HALEY WARD

23 April 2025

**RE: Response to TAC Review Comments at 361 Hanover Street, Proposed Site Development and New Structures**

**SITE PERMIT PLANS**  
**PROPOSED DEVELOPMENT**  
**361 HANOVER STREET**  
**PORTSMOUTH, N.H.**

SITE PLAN C3

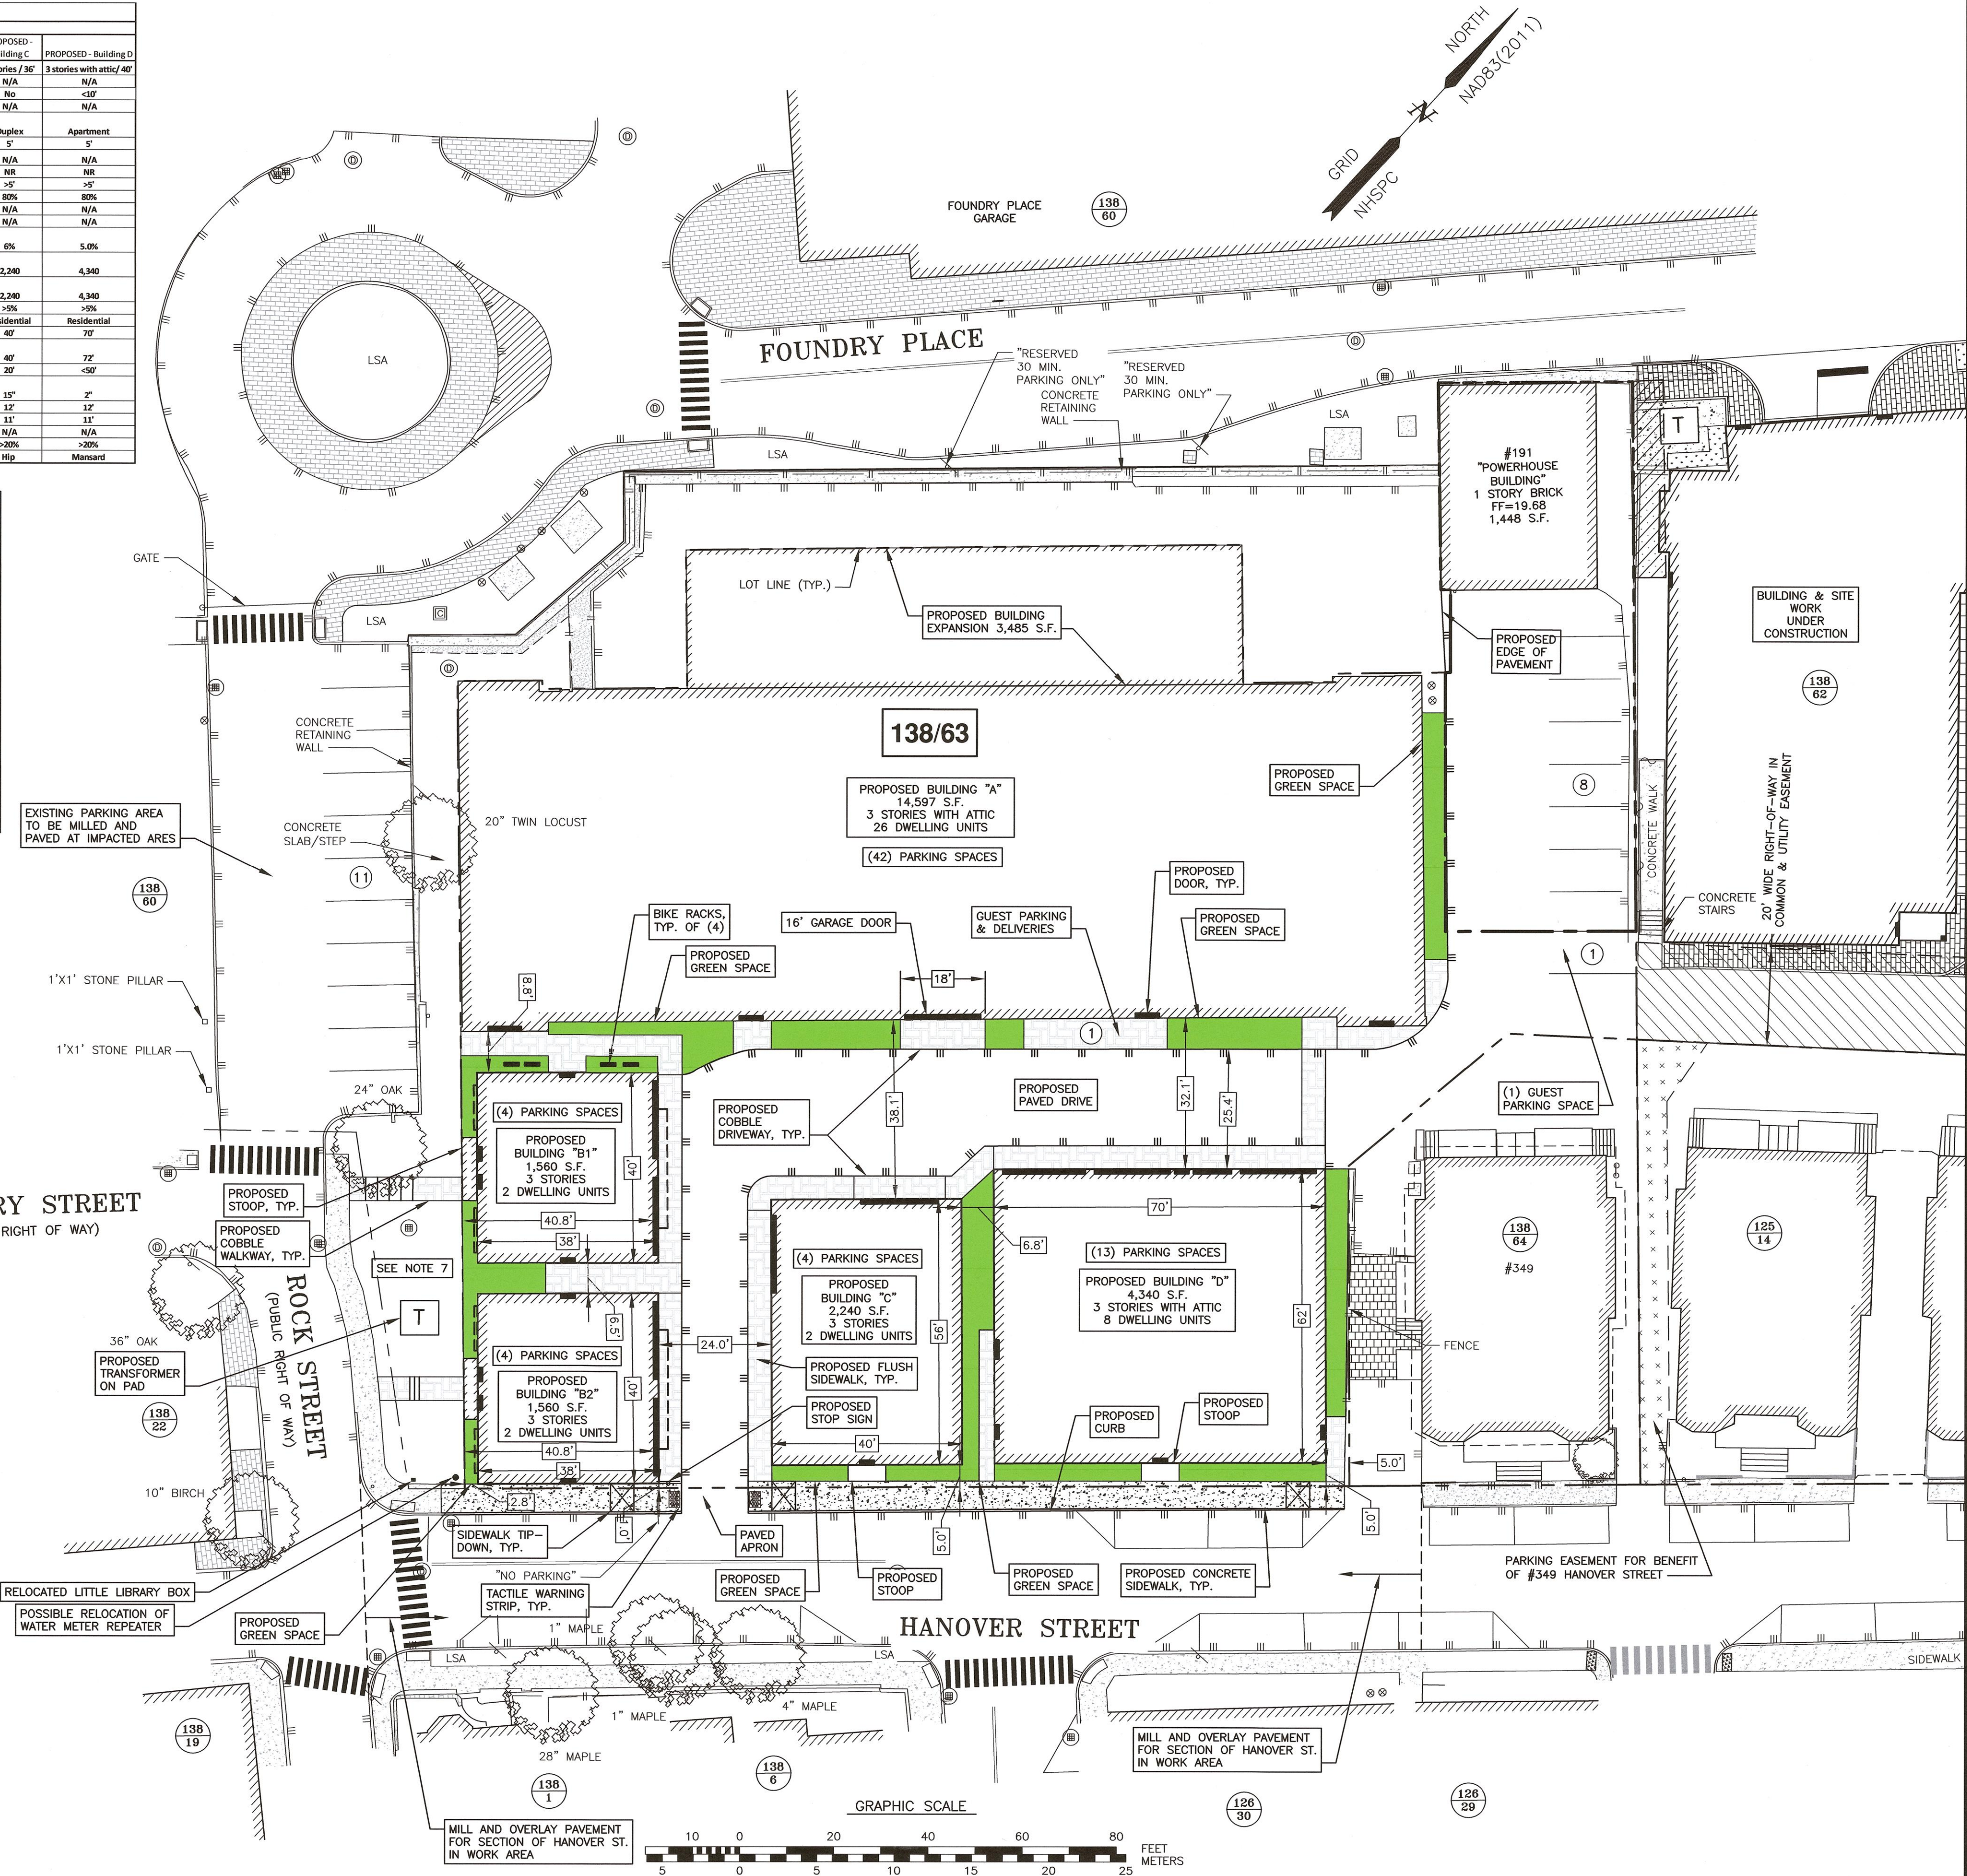
7. Please provide parking calculations for each lot (not per building), including guest parking calculation. **The Parking Calculations have been added to Site Plan Sheet C3.**

35. New driveway onto Hanover needs to be asphalt apron. Tipped curb needs tactile panels if stop sign is present. **The Site Plan C3 has been updated to add the apron and tactile panels.**

43. Rock Street parking Area will need to be milled and paved as well if it is being impacted during conduit installation. **A note has been added to Sheet C3.**

44. Foundry place will need to be milled and paved as well if it is being impacted during conduit installation. **A note has been added to Sheet C3.**
45. Why aren't the communications conduits going to communications pedestal? **Upon added review communications will come from existing pole PSNH 17 / 1.**

**Q**  
**C4** WATER MAIN & SERVICE CONNECTION  
COORDINATE WITH PORTSMOUTH DPW

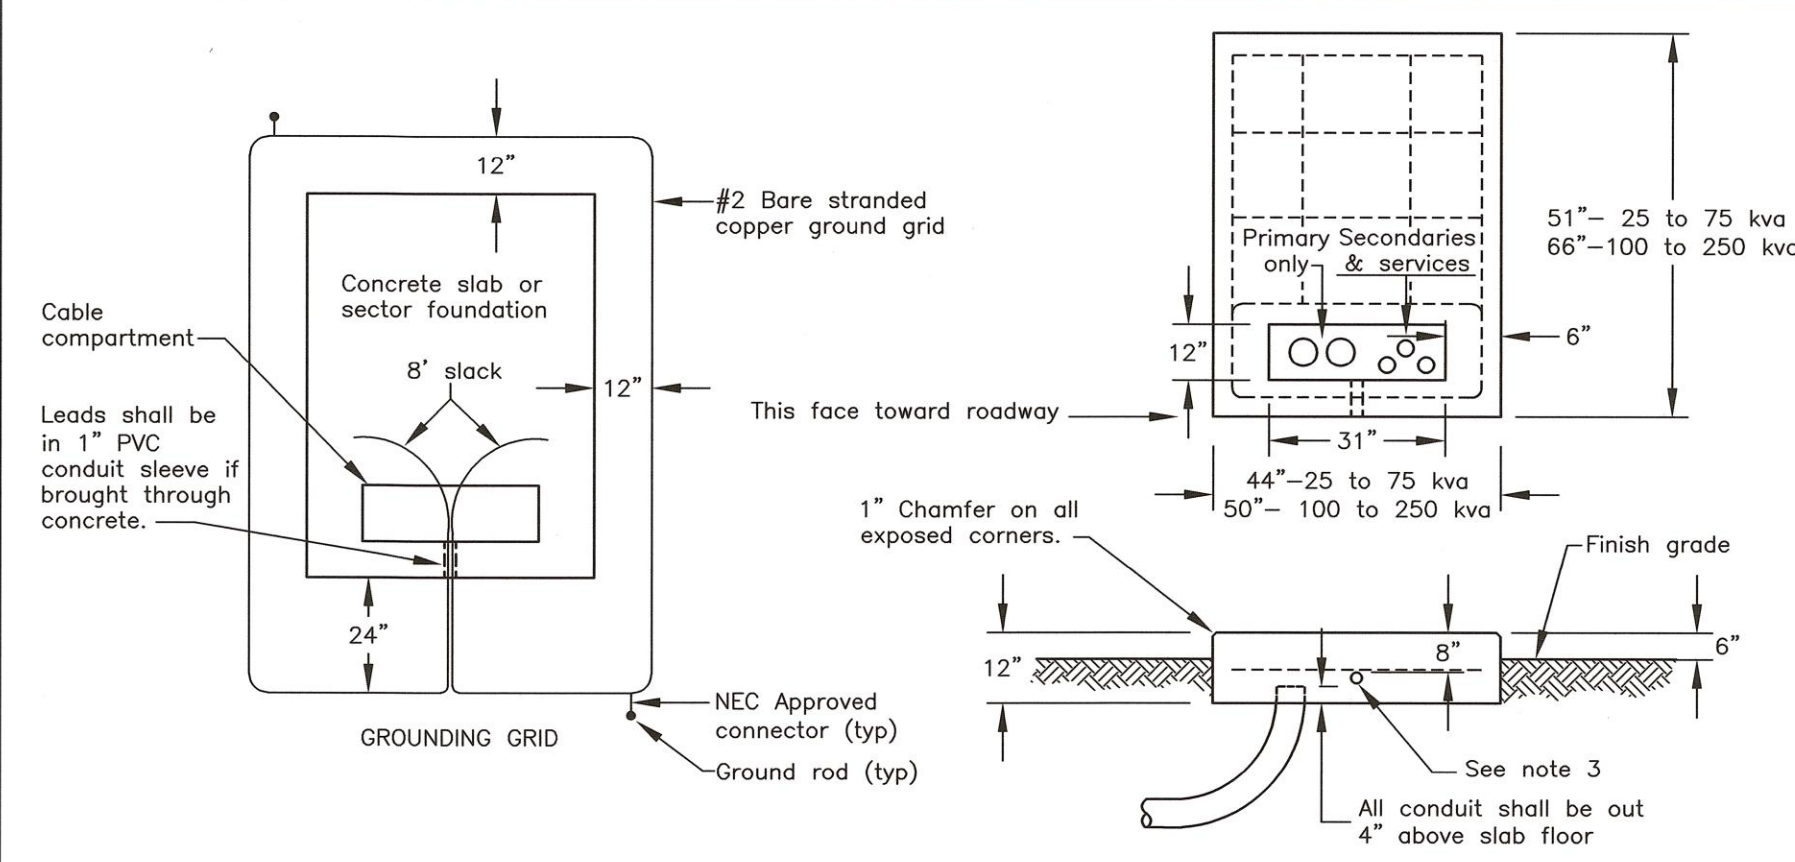
30. On water service detail, change 2" to size as noted in plan view. **The Detail Q on Sheet D3 has been updated.**
31. Show marking tape above utility lines in all appropriate details. **See Detail I on Sheet D2.**

32. Water service (not 'gate valves') shut off boxes in sidewalks (asphalt or pavers) are to be equipped with buffalo box covers at the finished surface. Use hayes box tops only in loamed areas. **See Detail Q on Sheet D3.**
